**Storyteller Overland, LLC
Customer Service Department
428 Industrial Lane
Birmingham, AL 35211**

**TO: Storyteller Overland Dealers
Subject: NHTSA Recall: 26V-183**

NHTSA 26V-183 Hilt Stairs

Rev04212026

Figure 5

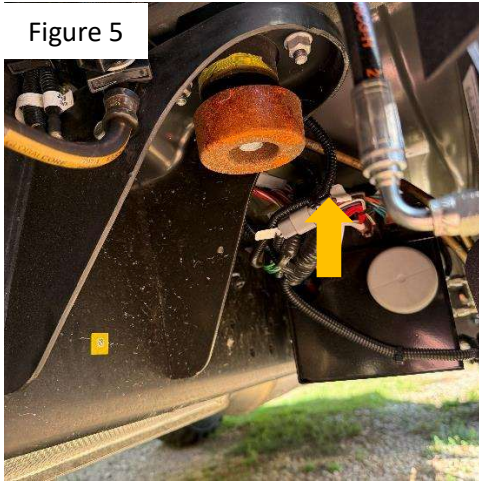
5. Begin fishing the wire toward the front of the vehicle replicating the path detailed in the following steps
6. Cross over the top of the liquid springs control module and secure with zip ties (Figure 5)
7. Follow the liquid springs harness forward until you reach the firewall, securing with zip ties every ~2ft (Figure 6)

Figure 7

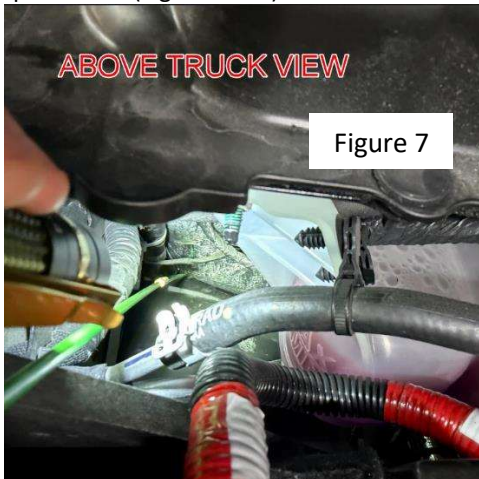
8. From the top of the engine compartment, pass your fish rod/tape down to underneath the vehicle in the spot shown (Figure 7 & 8)

Figure 11

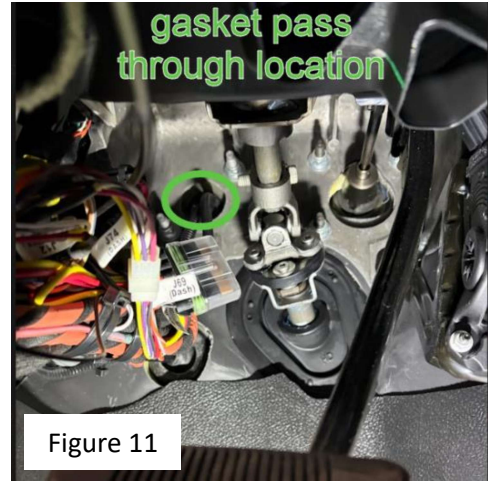
11. Remove the kick panel In the driver footwell using 7mm socket (Figure 10)
12. From the driver footwell, pass fish rod/tape through the grommet shown and into engine compartment. Take care to make sure the grommet stays in place. The grommet must be in place where wires pass through firewall. (Figure 11 & 12)
13. Attach wire to fish tape/rod and pull into driver footwell

MY 25+

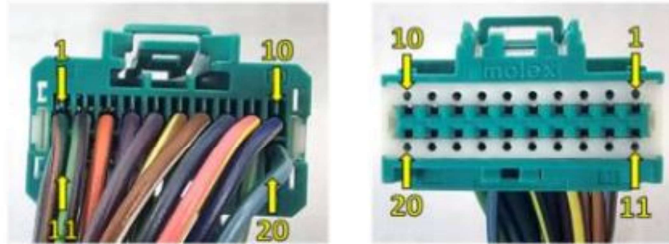
14. Locate the two wires shown on pictures below for the year Ram you are working on
 - a. **Model year 25+:** On VSIM Connector "C" 20 Cavity: pins 15 (reverse) and 17 (drive)
 - b. **Model Year 24 and under:** On VSIM Jumper 24 gray in-line connector: pins 12 (reverse) and 16 (drive)

MY 24 AND BELOW

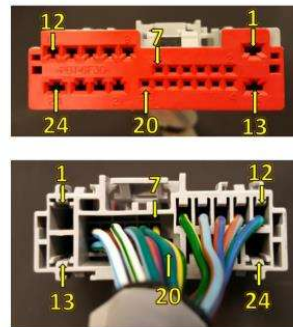
The VSIM Gray 24 Cavity In-line mating connector is located above the accelerator pedal bracket.

Figure 13

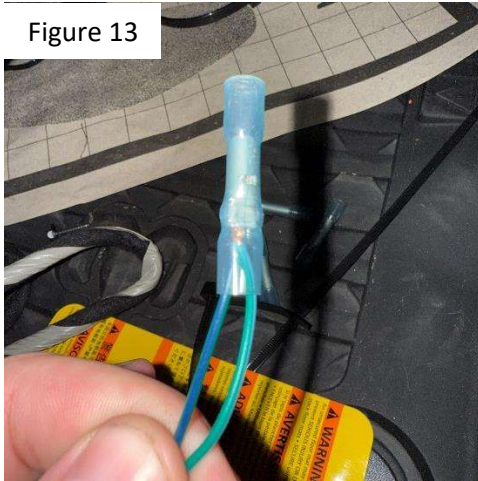
17. If wires were correct, take supplied butt connector, strip back both wires, Insert Into one end of the connector, and crimp (Figure 13)
18. Crimp the wire run In steps 5-12 Into the other end of connector and shrink heat shrink with heat gun

Figure 15

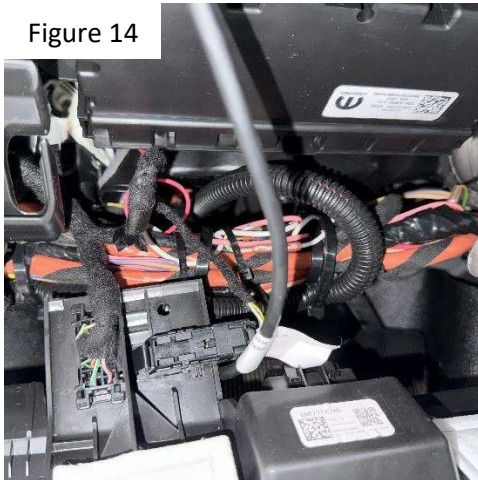
19. Tie up all of the wires cleanly underneath dashboard and replace kick panel (Figure 14)
20. Plug the steps connector removed In step 3 Into the supplemental harness (Figure 15)
